REPORT TO CITY OF VISALIA PLANNING COMMISSION

SUBJECT: **River Island Ranch Tentative Subdivision Map No. 5569:** A request by 4Creeks, Inc. to subdivide parcels totaling 55.99 acres into a 239-lot single-family residential subdivision and seven lettered lots for landscaping and lighting district purposes, located within the R-1-5 (Single-Family Residential, minimum 5,000 square foot lot size) zone. The project site is located on the east side of N. Dinuba Boulevard, approximately 600 feet north of E. Shannon Parkway and south of the St. John's River (APN: 079-071-001, 016; 079-080-045, 049, 052, 053, 055).

Thank you for the opportunity to review the *Revised* Traffic Impact Analysis (TIA) prepared for River Island Ranch subdivision (Project) under Tentative Subdivision Map (TSM) No. 5569 which proposes to divide 7 parcels totaling 55.99 acres into 239 residential lots. The Project proposes to be constructed in two phases (153 lots on the 1st phase and 86 lots on the 2nd phase). The Project's proposed site is located on the eastside of State Route (SR) 63 (Dinuba Boulevard), south of the St. John's Bridge and north of the SR 63 / Shannon Parkway intersection.

DINUBA BLVD CROSS SECTION (LOOKING NORTH)
AT RIVERWAY AVE.

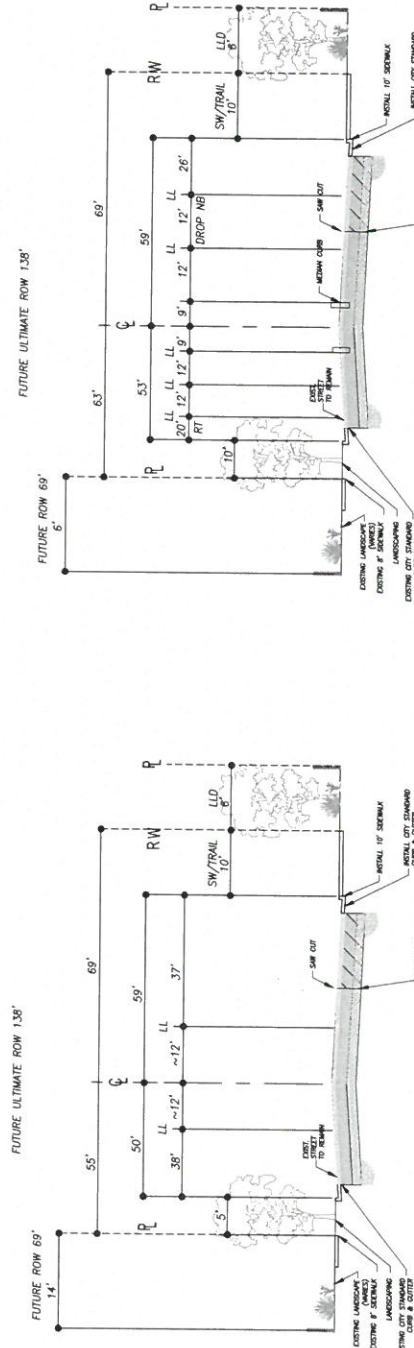
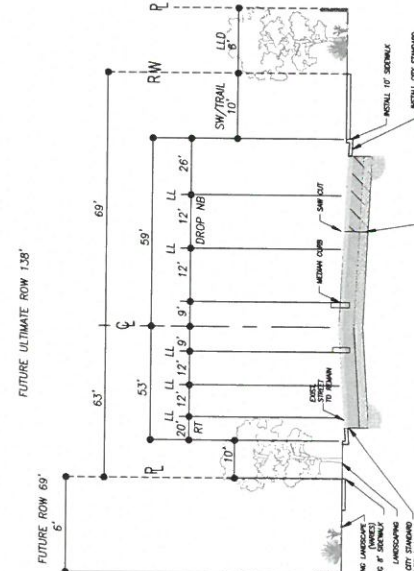
14. Caltrans has requested to review the proposed SR 63 cross sections along the Project's frontage. These cross sections should show the ultimate right-of-way and should consider the future northbound left turn lane to Riverway Drive.

4. Per Caltrans letter dated September 5, 2018 (attached), comment #14 indicates, the ultimate transportation corridor concept along this segment of SR 63 is a 6-lane conventional highway. An Irrevocable Offer of Dedication (IOD) to Caltrans for 19 feet of right-of-way is needed to accommodate the ultimate configuration of SR 63.

5. Per Caltrans letter dated September 5, 2018 (attached), comment #13 indicates that the Project should widen and improve SR 63 along its frontage to accommodate a raised median, two northbound lanes, standard shoulder and a Class II bike lane, curb and gutter, landscape strips, and sidewalk as part of opening day mitigation.
